**METROPOLITAN GOVERNMENT OF NASHVILLE AND DAVIDSON COUNTY**

**STAFF RECOMMENDATION**  
**2203 Grantland Avenue**  
**May 15, 2013**

**Application:** Demolition—Outbuilding; New Construction—Outbuilding; Setback reduction

**District:** Woodland in Waverly Historic Preservation Zoning Overlay

# SITE PLAN

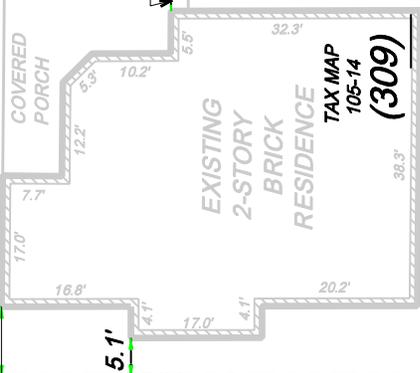
**Setback and Rhythm of Spacing:** The outbuilding is located in the rear of the property, as is appropriate for outbuildings. The enclosed portion of the structure has a footprint of seven hundred and twenty-four square feet (724 sq. ft.), and attached to it is an open carport structure that is three hundred and twelve square feet (312 sq. ft.). Base zoning requires that an outbuilding that is more than seven hundred square feet be five feet (5') from the side property lines and twenty feet (20') from the rear property line. In this case, the outbuilding will be three feet (3') from north side property line, four feet (4') from the south side property line, and six feet (6') from the rear property line. Staff finds the reduction of the setbacks to be appropriate in this instance because historically this property had an outbuilding on it that sat on the rear property line. In addition, the 1914 Sanborn map shows that several properties had outbuildings that sit on the rear property line and less than five feet (5') from the side property lines (See Figure 3). Staff further finds the setback reduction to be appropriate because, currently, there are several outbuildings on the street that do not meet the base zoning requirements for setbacks (see Figures 4 & 5).

Staff finds that the location of the outbuilding and the setback reduction meet Sections III.B.2.c. and III.B.2.h. of the *Woodland in Waverly Historic Zoning District: Handbook and Design Guidelines*.

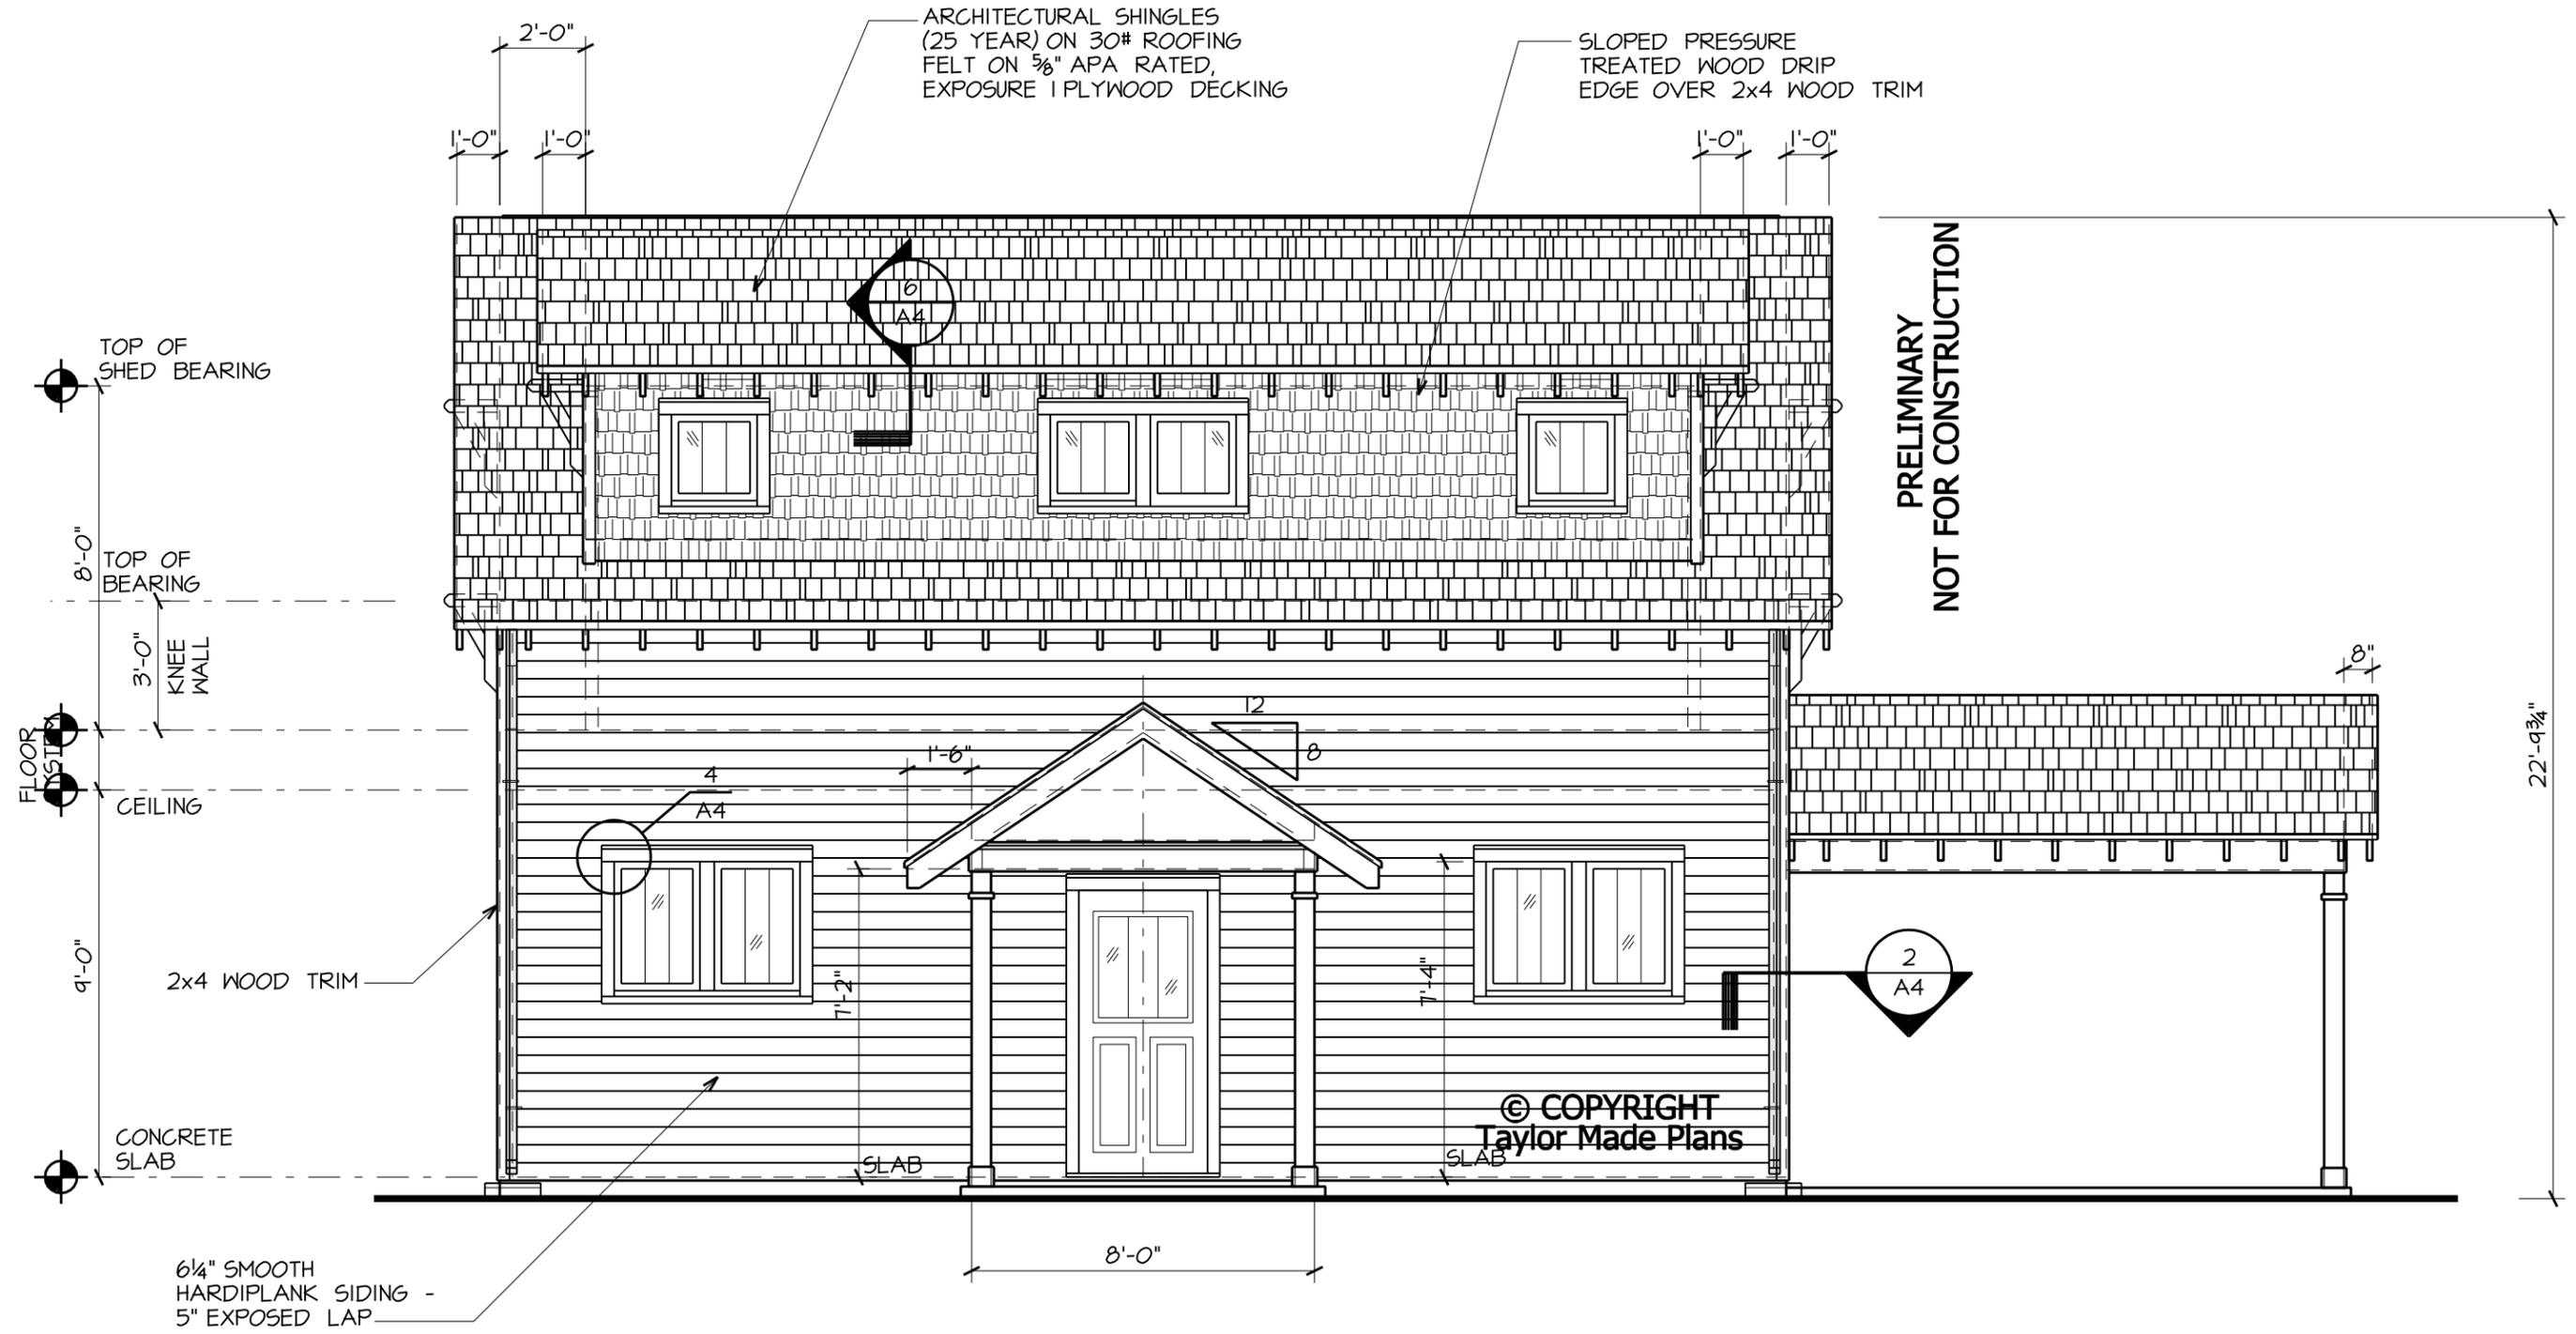
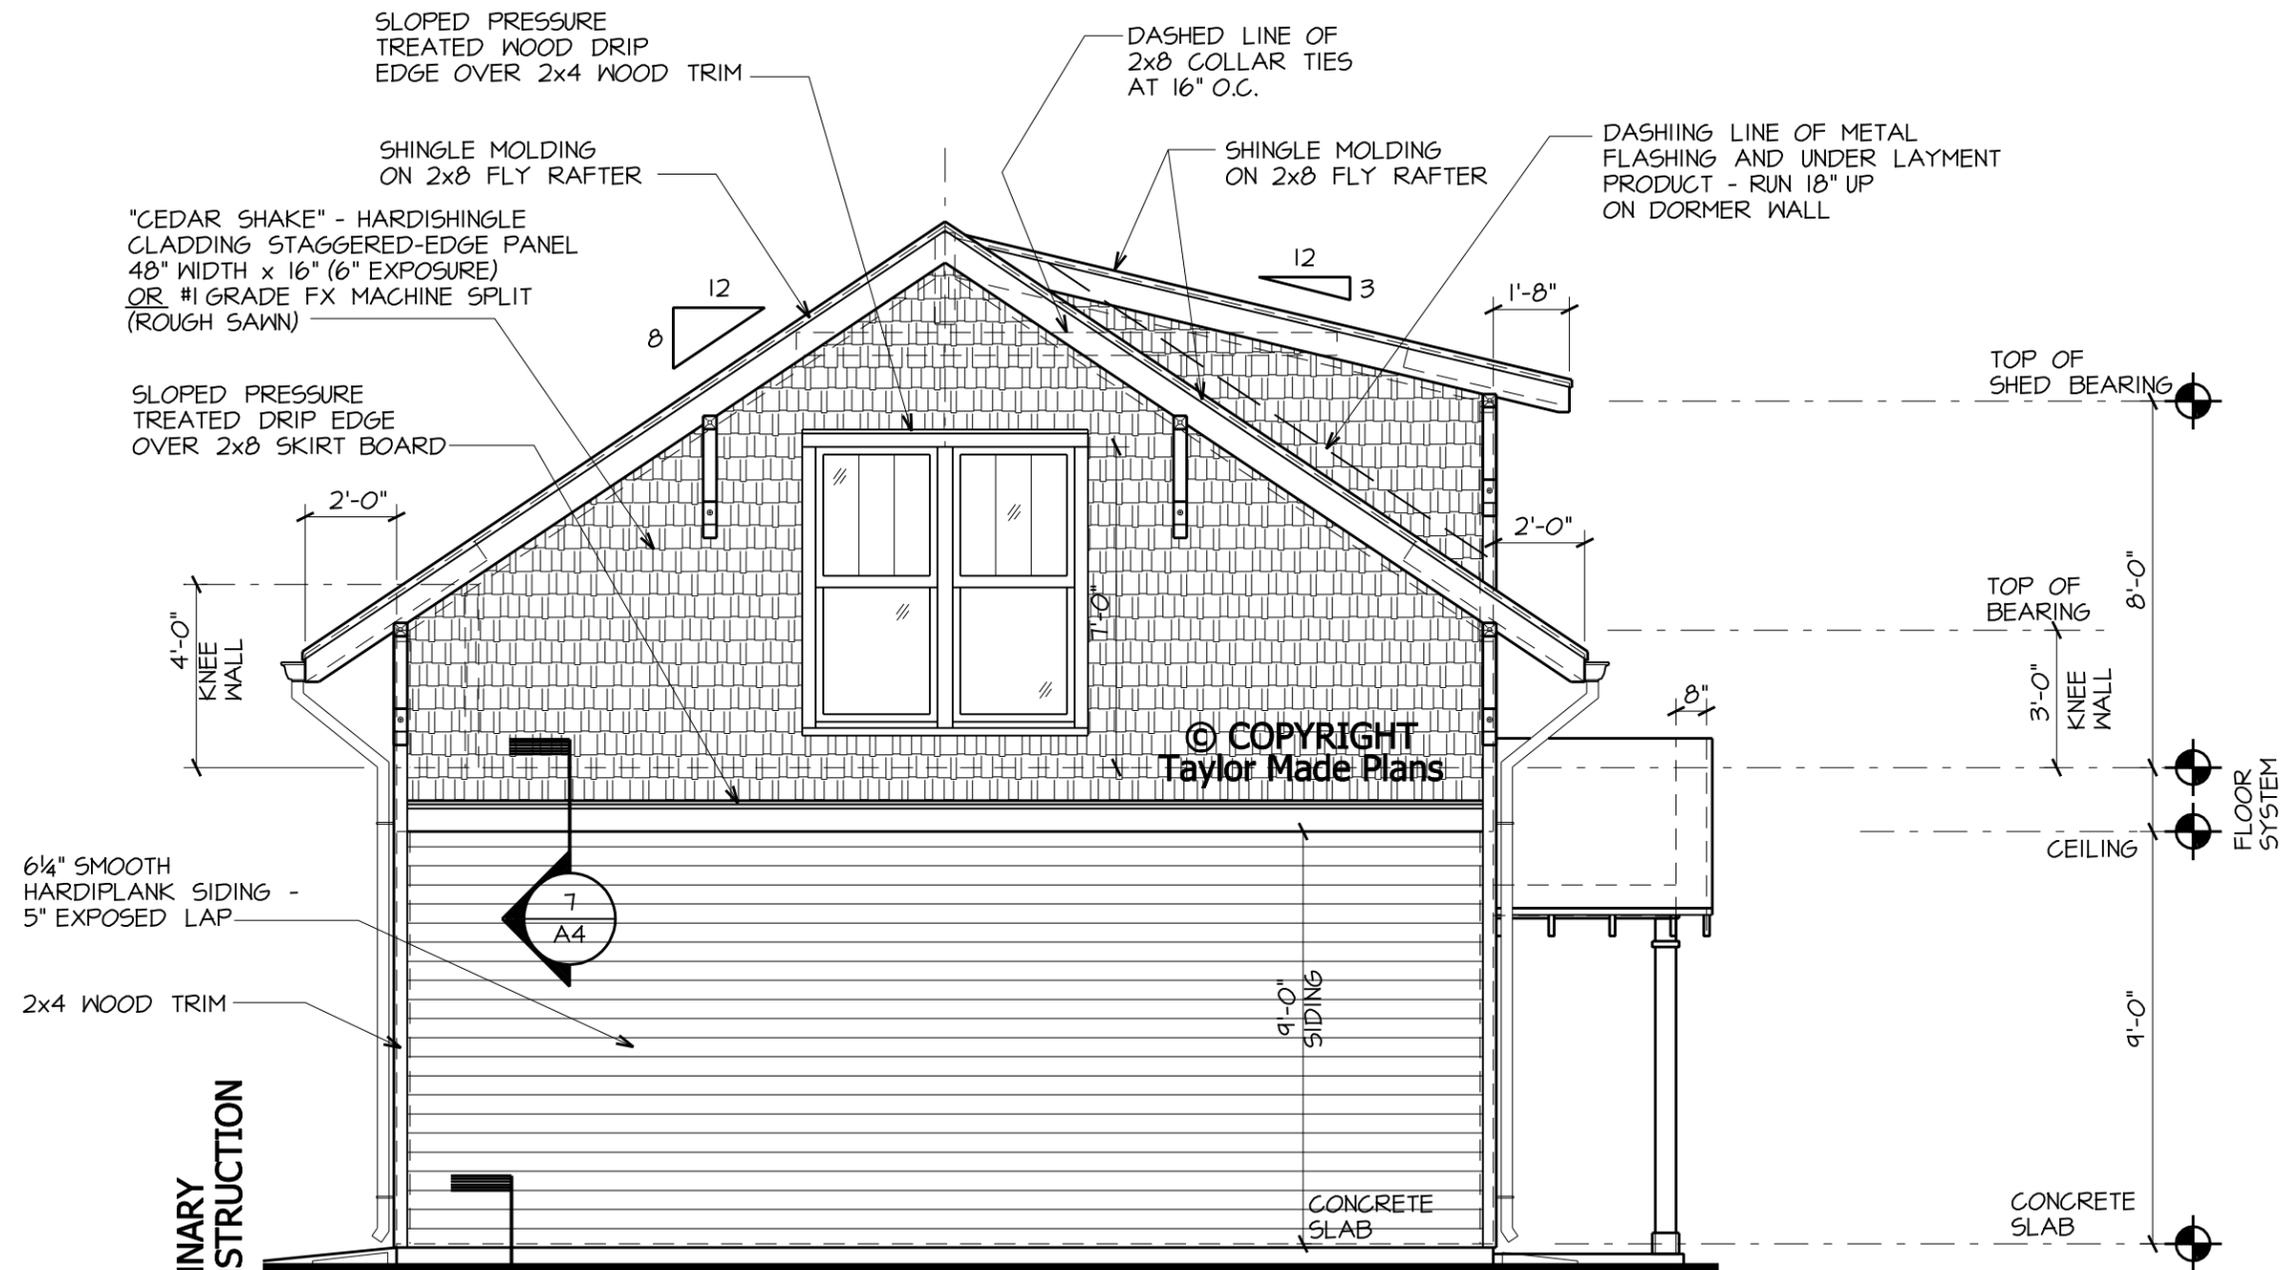
Height and Scale: The outbuilding has an enclosed garage element and an open carport element. The enclosed garage is one and a half stories with an eave height of approximately thirteen feet, three inches (13'3") from grade and a ridge height of approximately twenty-two feet, nine inches (22'9"). The enclosed garage is thirty feet (30') wide and twenty-four feet (24') deep, and therefore its footprint is seven hundred and twenty-four square feet (724 sq. ft.). The open carport element is one story in height with an eave height of approximately eight feet, five inches (8'5") and a ridge height of approximately eleven feet, eight inches (11'8"). The open carport element is thirteen feet (13') wide and twenty-four feet (24') deep, and therefore it has a footprint of three hundred and twelve square feet (312 sq. ft.). In total, the new structure will have a footprint of one thousand and thirty-six square feet (1,036 sq. ft.). This footprint is larger than typical outbuildings in the neighborhood, but staff finds it to meet the design guidelines because approximately one-third of the structure will be an open carport element that is only one-story in height. In addition, the footprint of the outbuilding is subordinate to that of the house, which has a footprint of approximately two thousand, four hundred square feet (2,400 sq. ft.). Staff also finds that the height of the outbuilding is subordinate to that of the house and does not contrast greatly with other outbuildings in the district. The addition of the outbuilding does seem to negatively affect the site's open space.

Materials: The known materials for the outbuilding have all been approved by the Commission in the past. The primary cladding material will be Hardiplank lap siding with a five inch (5") reveal. Hardishingle siding to mimic cedar shake will be used in the gable and dormer fields. The trim will be wood, the foundation will be a concrete slab, and the roof will be architectural shingles. Staff asks to review the shingle color. The materials for the windows, doors, and posts were not specified, and staff asks to approve them prior to purchase and installation. With the staff's final approval of the windows, doors, asphalt shingle color, and post material, staff finds that the materials meet Sections III.B.2.d. and III.B.2.h. of the *Woodland in Waverly Historic Zoning District: Handbook and Design Guidelines*

Roof Shape: The roof form for the enclosed portion of the outbuilding will be a side gable with a roof slope of 8/12. The structure includes a covered entryway with an 8/12 slope. The house-facing façade of the structure will have a shed dormer with 3/12 slope. The dormer is not inset from the wall of the structure, but that can be appropriate on an outbuilding. The covered carport portion of the addition will have a side gable with a slope of 3/12. The outbuilding's roof forms are all found in the district and are appropriate for an outbuilding. Staff finds that the roof form meets Sections III.B.2.e. and III.B.2.h. of the *Woodland in Waverly Historic Zoning District: Handbook and Design Guidelines*

Proportion and Rhythm of Openings. The structure's proportion and rhythm of openings are appropriate for a detached outbuilding in the rear of the lot. Staff therefore finds that the structure's proportion and rhythm of openings meet Sections III.B.2.g. and III.B.2.h. of the *Woodland in Waverly Historic Zoning District: Handbook and Design Guidelines*

**Recommendation Summary:** Staff recommends approval with the condition that staff approve the windows, doors, asphalt shingle color, and post material. With this condition, staff finds that the project meets III.B.2 and V.B.2. of the *Woodland in Waverly Historic Zoning District: Handbook and Design Guidelines*.
